Comments
on
Environmental Impact Report
for the
Phillips 66 Propane Recovery Project
Rodeo, California

Prepared
for
Shute, Mihaly & Weinberger LLP on behalf of
Rodeo Citizens Association

November 15, 2013

Prepared by
Phyllis Fox, Ph.D., PE
Consulting Engineer
745 White Pine Ave.
Rockledge, FL 32955

Figure 1
Overall Existing Refinery Block Flow Diagram

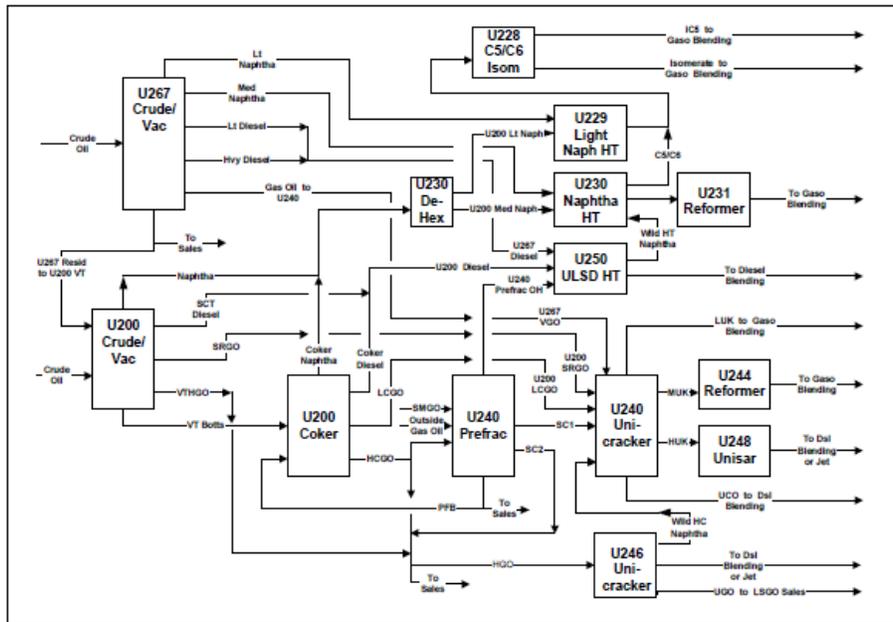
This link is clearly shown in the Rodeo Refinery block flow diagrams in the subject Rodeo Refinery DEIR. The block flow diagram for the existing Rodeo Refinery, DEIR Figure 3-4, shows "SMGO" entering the Refinery at the U-240 Prefractionator unit (Prefrac unit). DEIR, p. 3-12 ("Heavy gas oil (HGO) streams from Unit 200 and HGO purchased from outside of the Refinery are fractionated in the Unit 240 prefractionator."). SMGO is Santa Maria Gas Oil. This DEIR figure is reproduced here as Figure 1 for ease of reference. The U-240 Prefrac unit separates Santa Maria gas oil and other gas oils into lighter hydrocarbon fractions that are currently blended into the Refinery Fuel Gas, shown in Figure 3-5 (see lower left hand corner, blue arrow labeled U-240/244/248 S-RFG being routed to U-240 Fuel Gas Treating), but which will be further processed into propane and butane in new units added to the Rodeo Refinery as part of the Project.

Figure 2
Proposed Refinery Fuel Gas System Block Flow Diagram

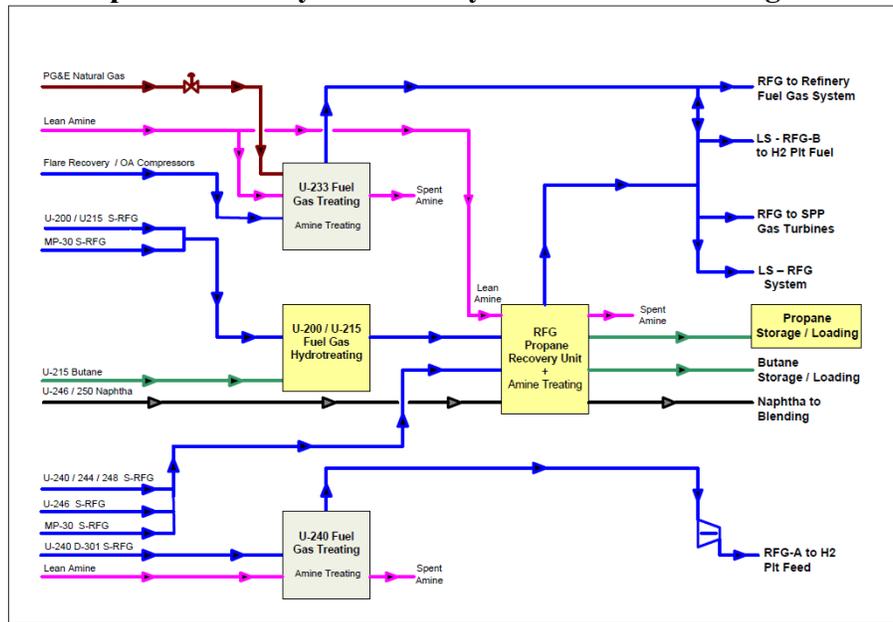
The RFG Propane Recovery Unit is the big yellow box in the middle of Figure 2. Blue arrows in the lower left hand corner of Figure 2 identify the inputs to this unit, which are various refinery streams. These streams include "U-240/244/248 S-RFG." This designation means that Refinery Fuel Gas (RFG) from Unit U-240 is sent to the RFG Propane Recovery Unit. (This stream was formerly sent to the U-240 Fuel Gas Treating Unit. DEIR, Fig. 3-5.) As Santa Maria Gas Oil (SMGO) is one of the inputs to Unit U-240, changes at the Santa Maria Facility would be transmitted directly to the Project via the U-240 Prefrac Unit.

This establishes a direct link between this Project and modifications at the Santa Maria Facility. This is the "nexus" to the larger project with the potential to change crude oil feedstocks.
